CORRECTED BY STAFF ON 9/28/89
CITY PLANNING COMMISSION

LOCATION: 501 - 509 12th Street

PROPOSAL: The applicant is requesting the necessary entitlements to construct a 5,400 sq. ft. commercial building.

12TH & "E" STREET
COMMERCIAL BUILDING

PLAN

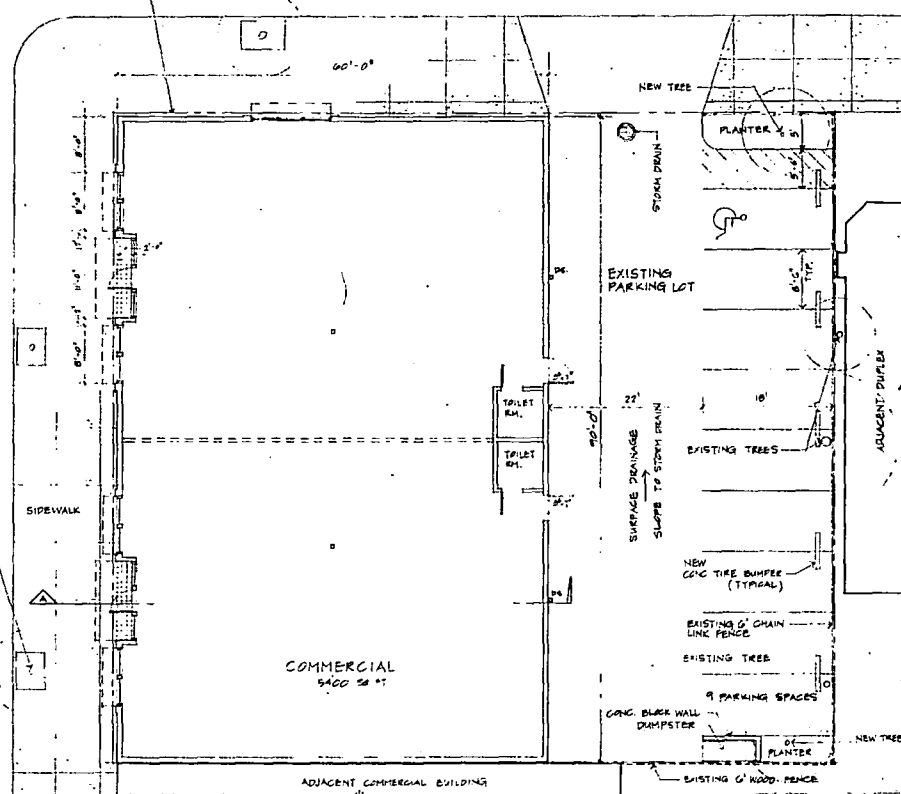
Staff has concerns about reducing the E Street setback to 0 feet. The properties to the north are residential structures of historical significance. Staff recommends the applicant provide a 4 foot clear planter area along E Street east of the windows. This area should include a combination of shrubs and vertical plantings. This increase in the setback will create a better transition from the 0 setback at the corner and the 12 foot setback of the residences, as well as provide movement in the facade of the building.

A solid wall is required to separate residential and non-residential uses. The applicant has requested a variance of this requirement. Staff supports this request. The residences to the east are historical significant structures and located within a foot of the property line. A wall would detract from the appearance of these residences. Staff recommends a 6 foot wooden fence with climbing vines. A small planter can be created for these vines by placing a continuous 6 inch raised concrete curb along the fence line where the wheel stops are shown. The vehicles will overhang this planter area.

The trash enclosure is located in the southeast corner of the parcel. This trash enclosure must meet the requirements of the Zoning Ordinance including a man door and perimeter landscaping. The handicapped parking stall shall be 9 feet wide with the adjacent loading area 5 feet wide.

1. Minimum driveway width is 24 feet.
2. Driveway flares are incorrect (City Standard is 3 ft.).

3. Maneuvering depth is to be 26 feet.

1. The awnings projecting into the public right-of-way require a revocable encroachment permit.
2. The applicant shall step a portion of the building back along E Street to provide a 4 foot clear planter area east of the windows of the building. This planter shall include a combination of shrubs and vertical plantings.
3. The applicant shall create a small planter along the fence line and plant climbing vines to cover the fence.

4. The trash enclosure shall meet the requirements of the Zoning Ordinance.
5. The handicapped parking stall shall be 9 feet wide with the adjacent loading area 5 feet wide.
